Subject: AP1000 COL Standard Technical Report Submittal of APP-GW-GLN-018, Revision 0

APP-GW-GLN-018, Revision 0
“Alternate Steam & Power Conversion”

TITLE: **ALTERNATE STEAM AND POWER CONVERSION DESIGN**

Alternate Steam and Power Conversion Design

Figure 1.2-27

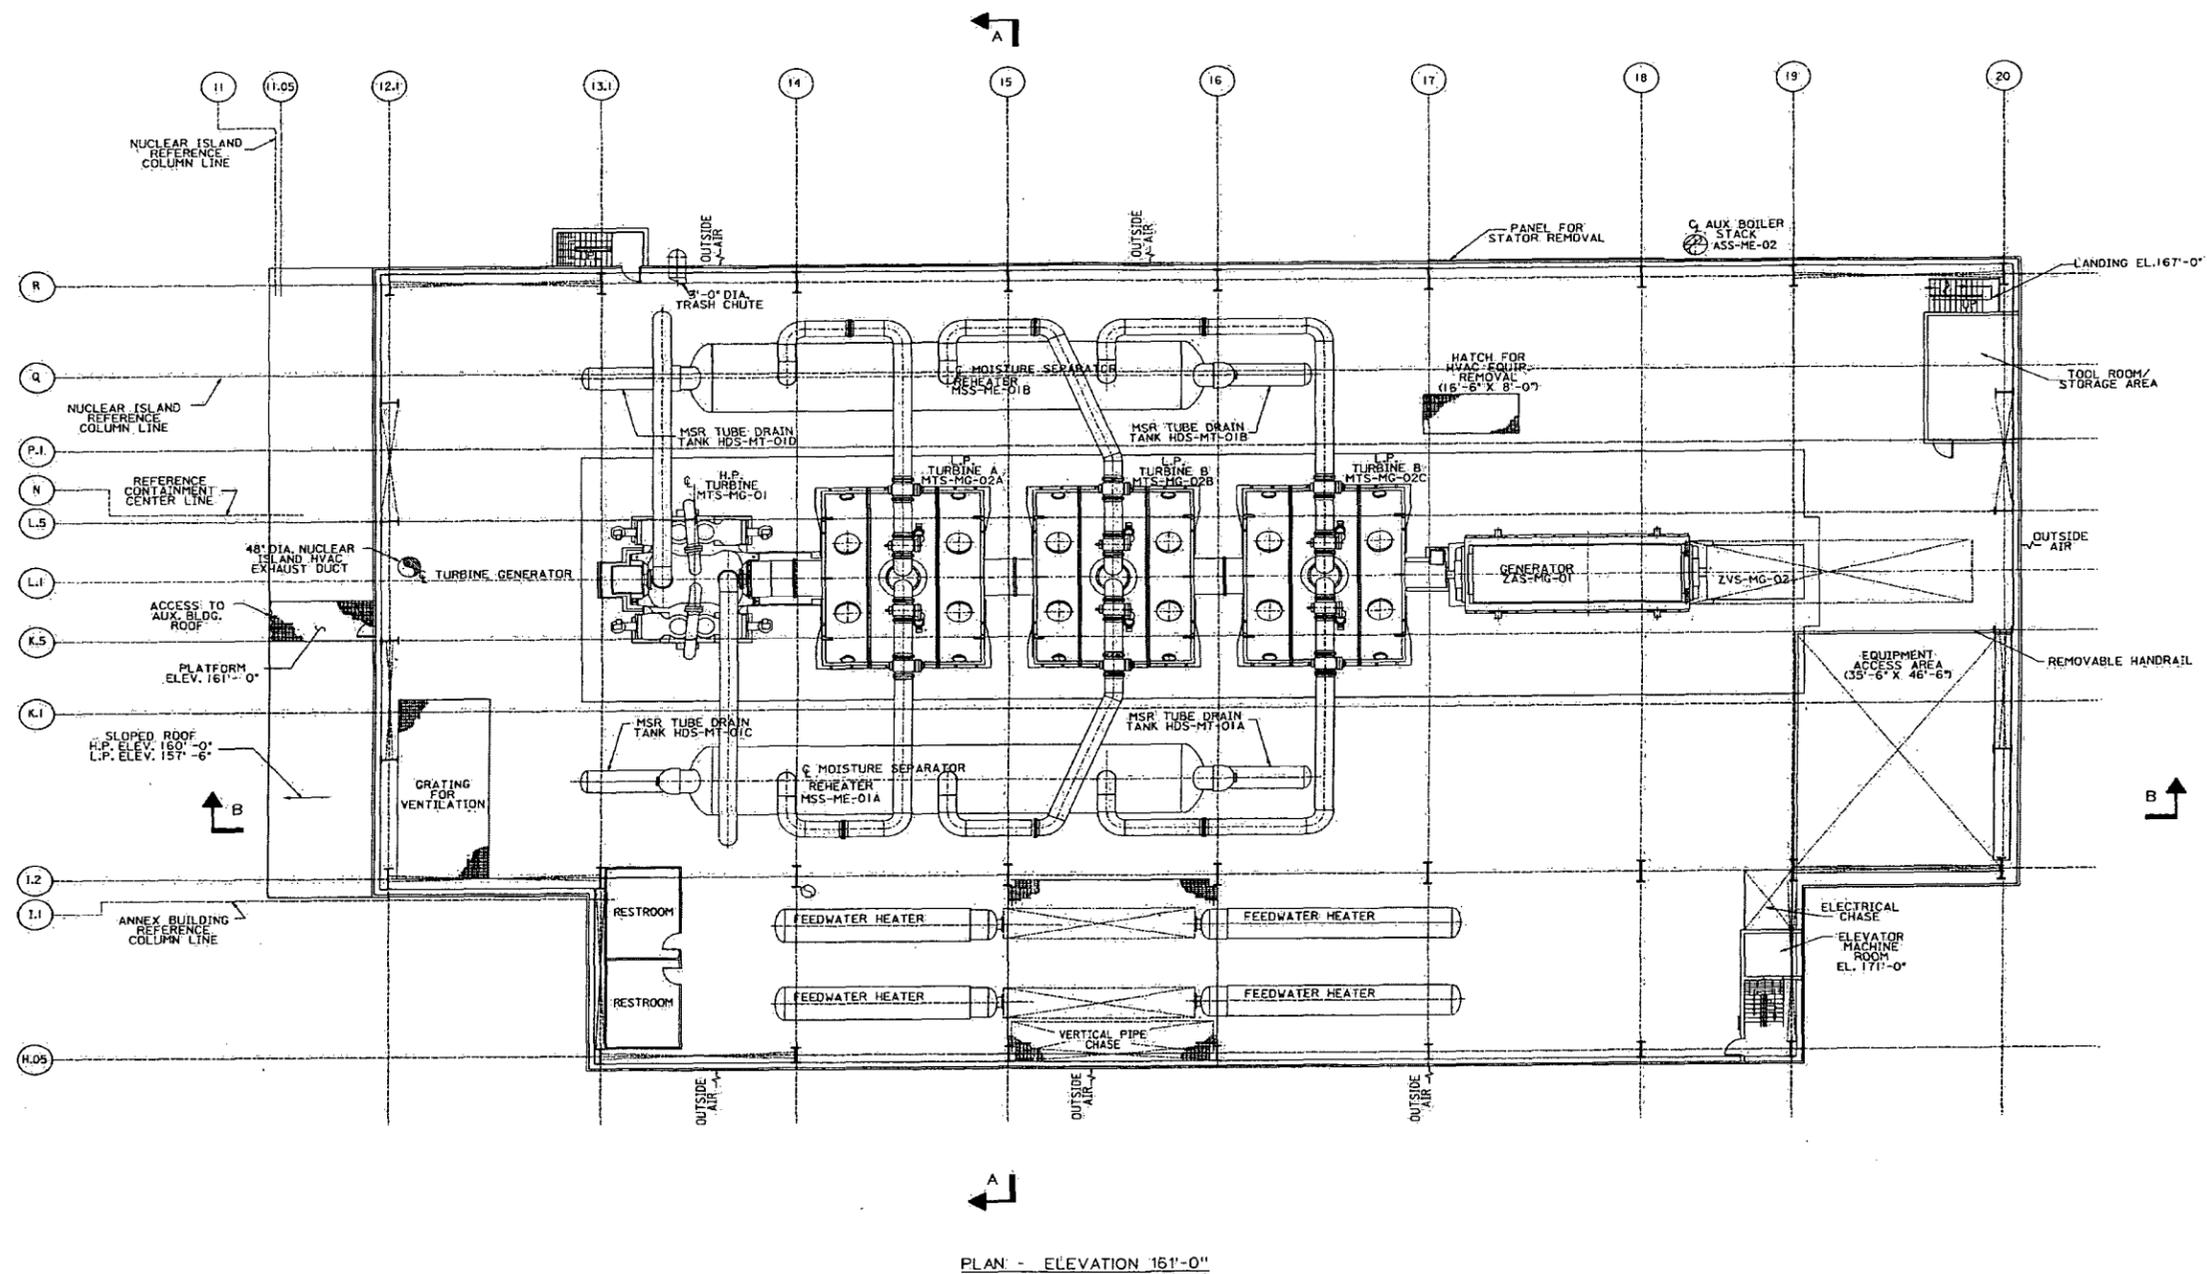
- The turbine is a power conversion system designed to change the thermal energy of the steam flowing through the turbine into rotational mechanical work which rotates a generator to provide electrical power. It consists of a double flow high pressure cylinder (high pressure turbine) and three double flow low pressure cylinders (low pressure turbines) which exhaust to the condenser. It is a six flow tandem compound, 1800 rpm machine. The turbine system includes stop, control and intercept valves directly attached to the turbine and in the steam flow path, crossover and crossunder piping between the turbine cylinders and the moisture separator reheaters.

- The high pressure turbine has a connection for one stage of feedwater heating (connections for two stages of feedwater heating on the alternate steam and power conversion design). The high pressure turbine exhaust steam provides steam for one stage of feedwater heating in the deaerator. The low pressure turbines have extraction connections for four stages of feedwater heating.

- The moisture separator reheater is an integral component of the turbine system which extracts moisture from the steam and reheats the steam to improve the turbine system performance. There are two moisture separator reheaters located between the high pressure turbine exhaust and the low pressure turbine inlet. The reheater has a ~~single stage~~two stages of reheat.

Figure 10A.1-1
Rated Heat Balance

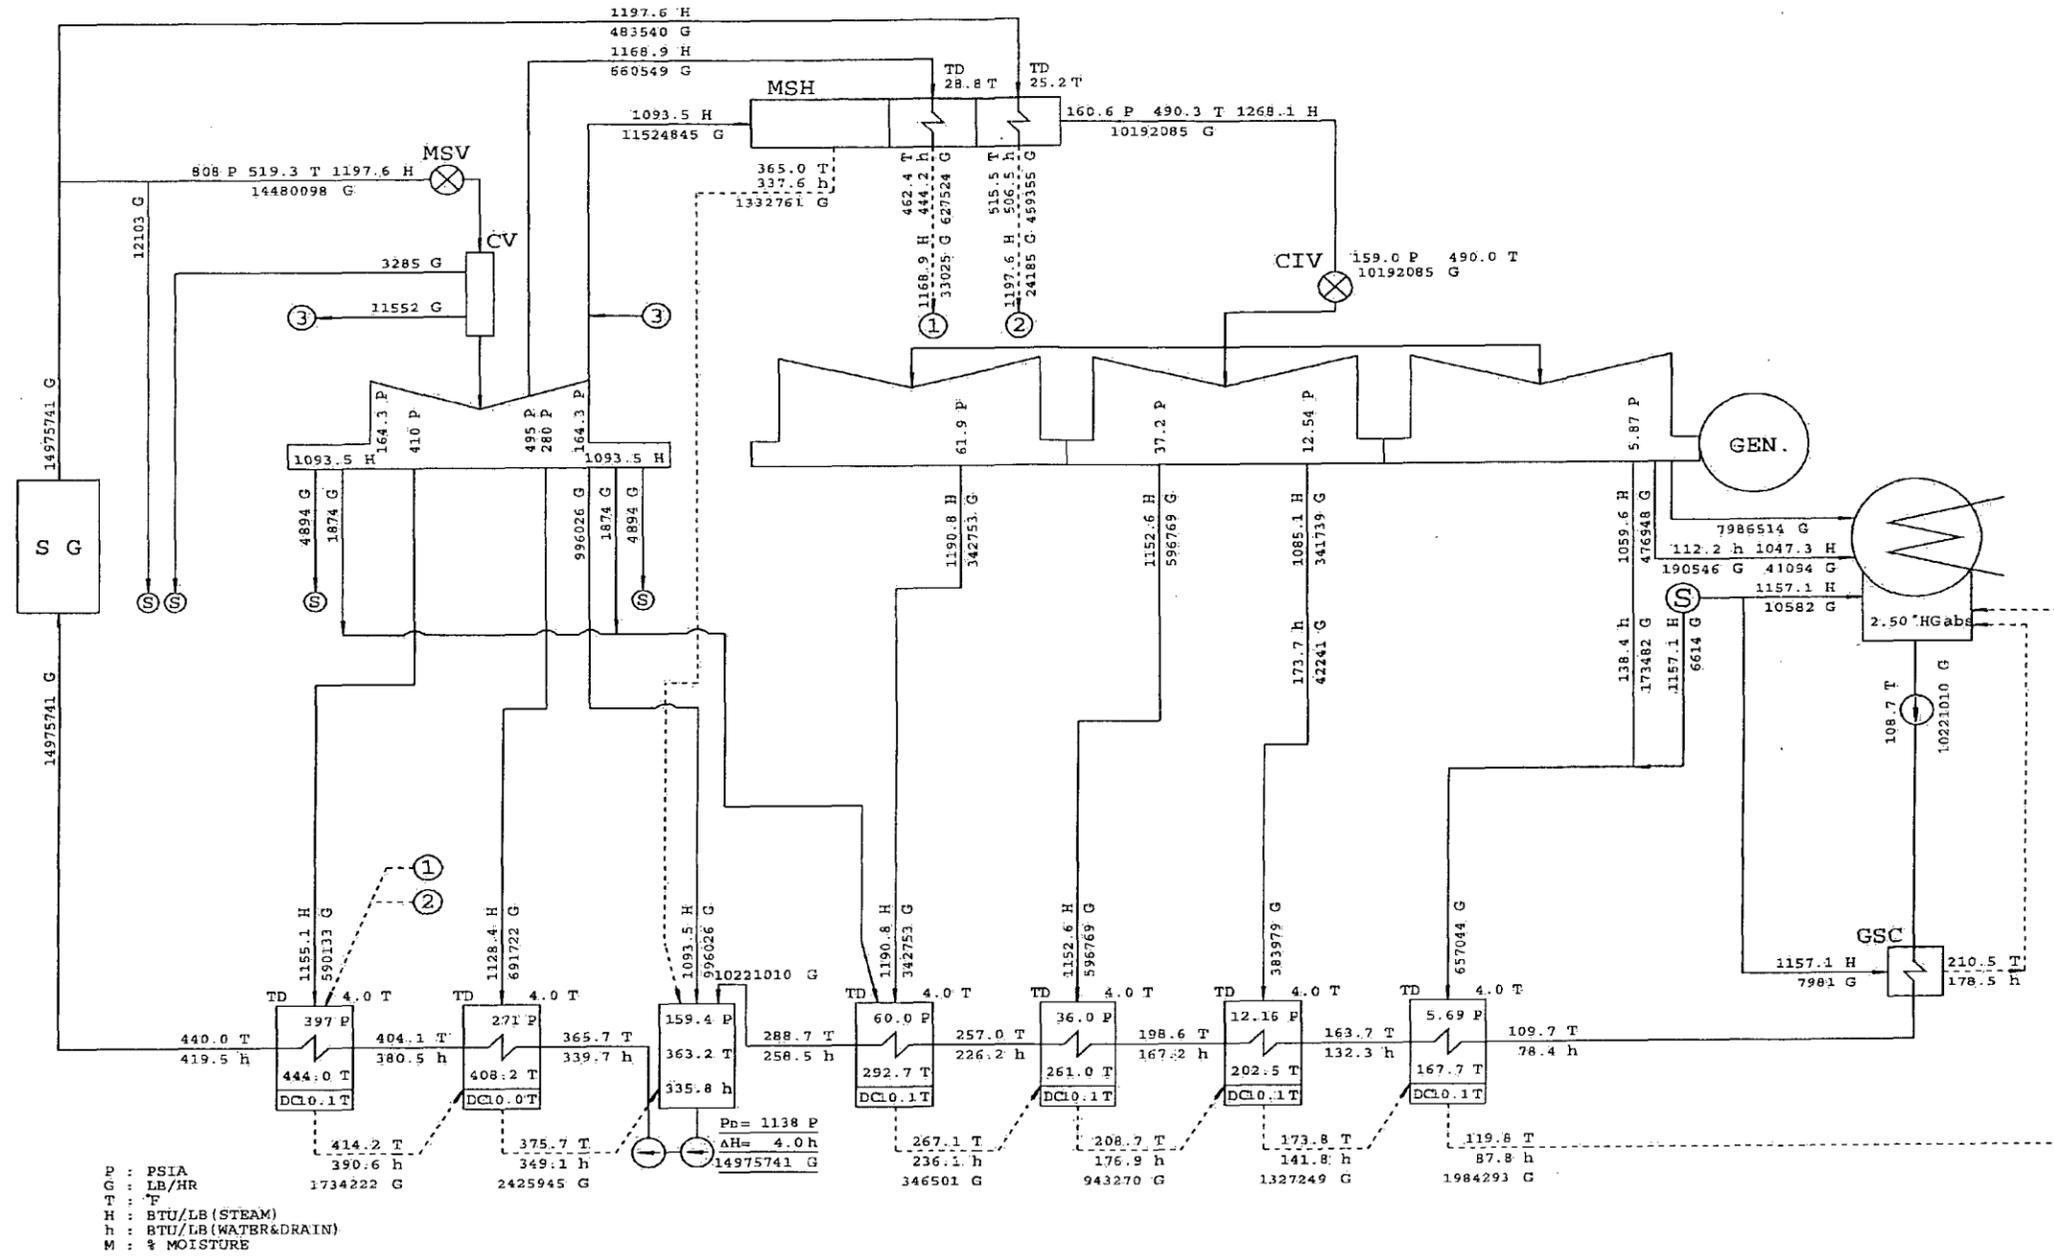
Table 4010A.1-1 gives the significant design and performance data for the major system components. Figure 4010A.1-1 shows the rated heat balance for the turbine cycle process.

<u>Nominal</u> Output (kW)	1,199,500 kW (<u>rated</u> heat balance value)
Turbine type	Tandem-compound, 6-flow, <u>5254</u> -in. last-stage blade
Turbine elements	1 high pressure 3 low pressure
Operating speed (rpm)	1800
